Subject: ENSR Modeling Protocol Review

Sullivan Environmental has reviewed the recently proposed modeling protocol submitted by ENSR Corporation for the Mirant Potomac River power plant in Alexandria, Virginia (ENSR, 2004). This review document summarizes our comments and findings of the issues that need further attention.

ENSR, 2004: Protocol for Modeling the Effects of Downwash from Mirant's Potomac River Power Plant. ENSR Corporation, Document Number 10350-002-400, October, 2004.

Figure 1. Marina Towers High Rise Building

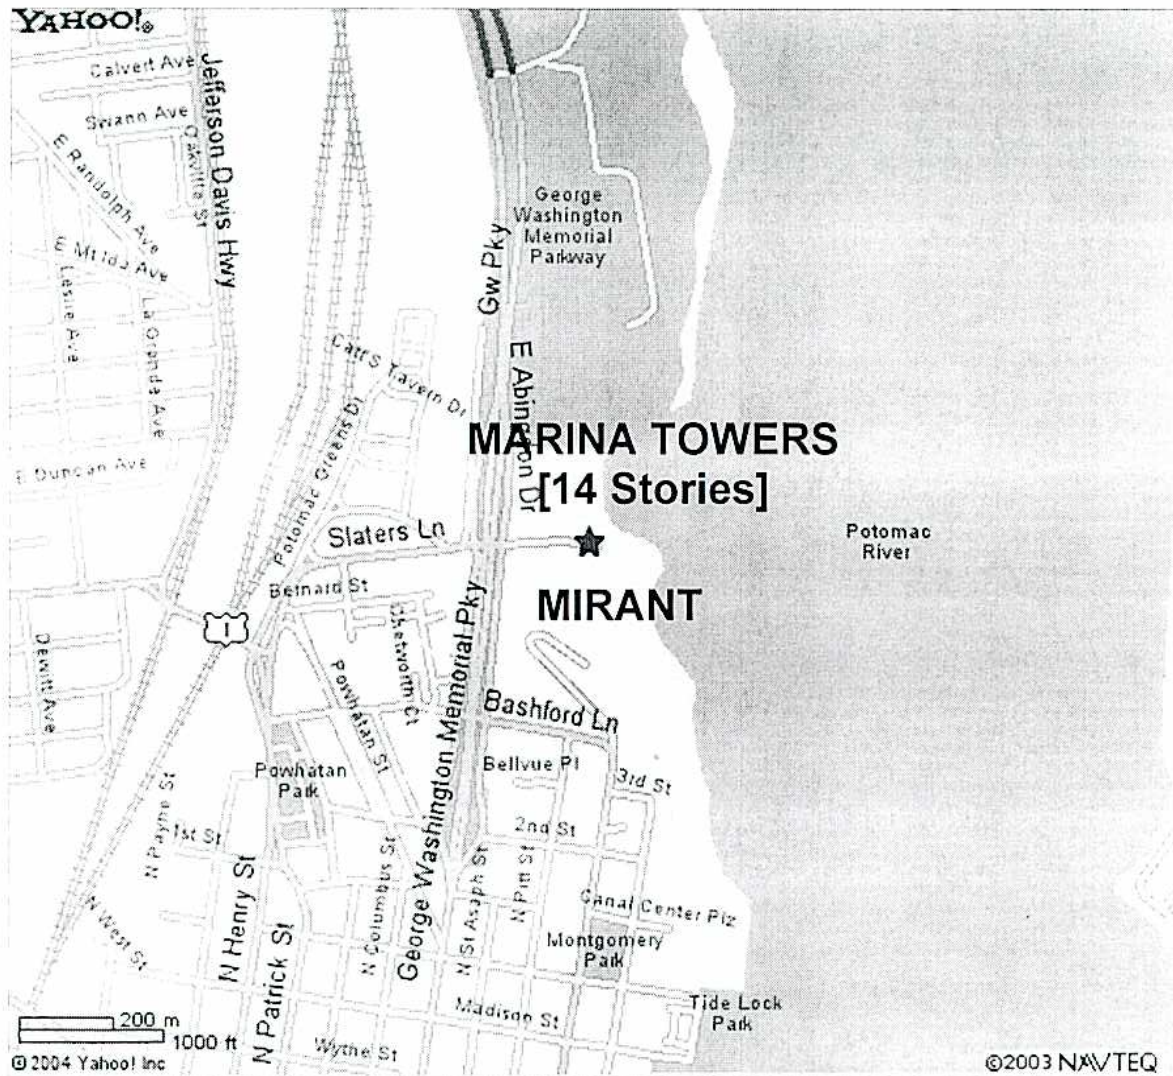
While terrain height is necessary, the more important modeling issue not being addressed in the model protocol is the fact there are high-rise residential buildings as close as approximately 100m of the power plant that need to be addressed as priorities in the model receptor grid. Figures 1 through 3 provide the relative locations of three example high-rise residential buildings to the Mirant power plant that need to be addressed in this modeling analysis, with flagpole receptors placed along each floor level of the buildings. Special discrete receptors representing the locations along with corresponding flagpole heights (above ground level) representing the height of these (and possibly other) high-rise buildings located within 1 kilometer of the Mirant power plant need to be incorporated into the model receptor grid. This flagpole height representation of the Marina Towers high-rise building was a key issue in the Sullivan screening model report mentioned in Appendix A of the model protocol (ENSR, 2004). As was stated in that screening model report: "The objective of this analysis was to evaluate the likelihood for plume impaction onto the upper floors of the Marina Towers complex." This key modeling issue is omitted in the ENSR model protocol.
